Determination 2015/033

Regarding the compliance of repairs proposed for the tile roof of a 7-year-old house at 6 Shadbolt Lane, Rolleston

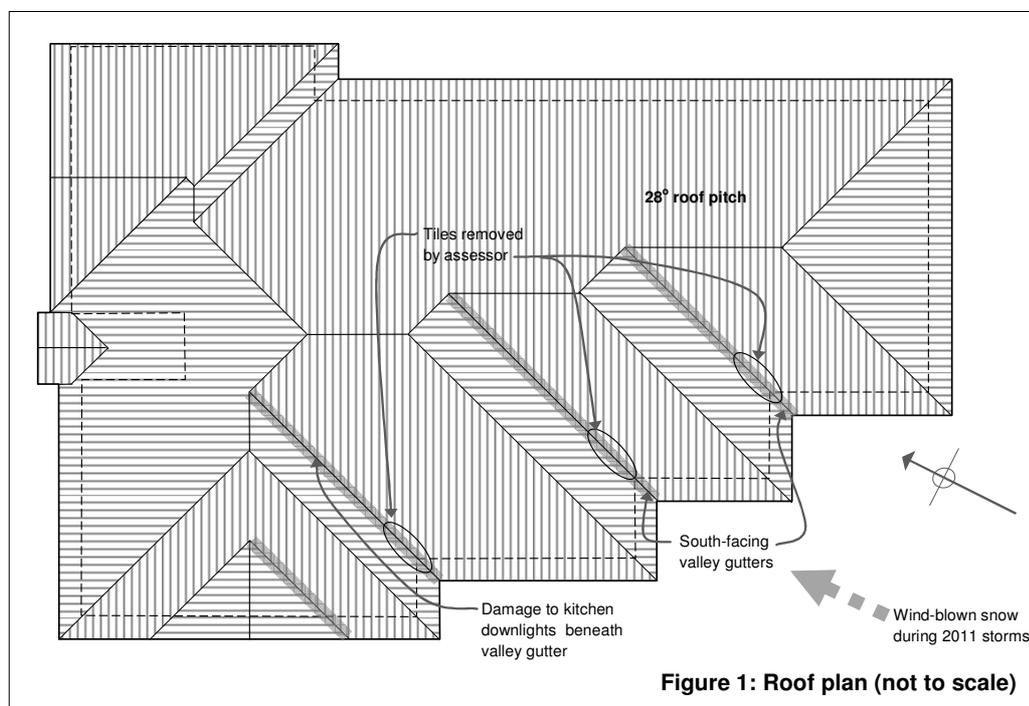
- 2.1 The subject roof repairs are on a detached house situated on a level semi-rural rural site in a high wind zone as described in NZS 3604⁴. Construction is generally conventional light timber frame, with a concrete slab and foundations, masonry veneer cladding, aluminium windows and concrete tile roofing.
- 2.2 The 28° pitched hipped roof includes gables above the northwest garage and entry canopy, and a small projecting gable to the southwest living area. The roof generally has eaves and verge overhangs, except above the northeast wall of the garage and the southwest projecting gable above the living area. The roof plan is fairly complex, with many valley gutters as shown in Figure 1.

3.3.1 In order to investigate the underlying construction, the assessor inspected the valley gutters and removed roof tiles at three locations (see Figure 1 at paragraph 2.2); contrasting the as-built junctions with comparable details in E2/AS1 and NZS 4206.
